# Product Safety Recall

## 17167 Loss of Power Steering Assist

**Reference Number:** A172093260

**Release Date:** August 2020  
**Revision:** 02

4780576

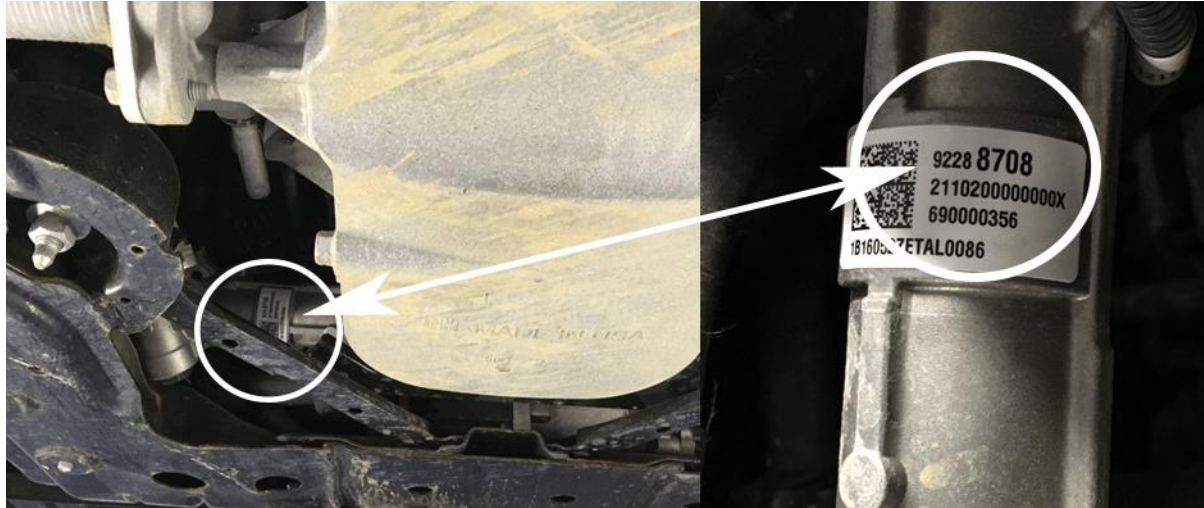
1. Raise the vehicle and remove the front bumper fascia extension. Refer to *Front Bumper Fascia Extension Replacement* in SI.
2. Inspect the part number on the electric belt drive rack and pinion steering gear:
  - If the vehicle steering gear part number IS NOT 92289255, 92289251, or 92288914, replace the steering gear assembly. Proceed to step 3.
  - If the vehicle has steering gear part number 92289255, 92289251, or 92288914 already installed, **record the part number of the currently installed gear in your warranty claim.** Reinstall the front bumper fascia extension. Refer to *Front Bumper Fascia Extension Replacement* in SI.
3. Remove the Electric Belt Drive Rack and Pinion Steering Gear. Refer to *Electric Belt Drive Rack and Pinion Steering Gear Replacement* in SI.

**Note:** Use Loctite 272 on the front lower control arm nut and bolt when reinstalling.

4. Install the Electric Belt Drive Rack and Pinion Steering Gear. Refer to *Electric Belt Drive Rack and Pinion Steering Gear Replacement* in SI.
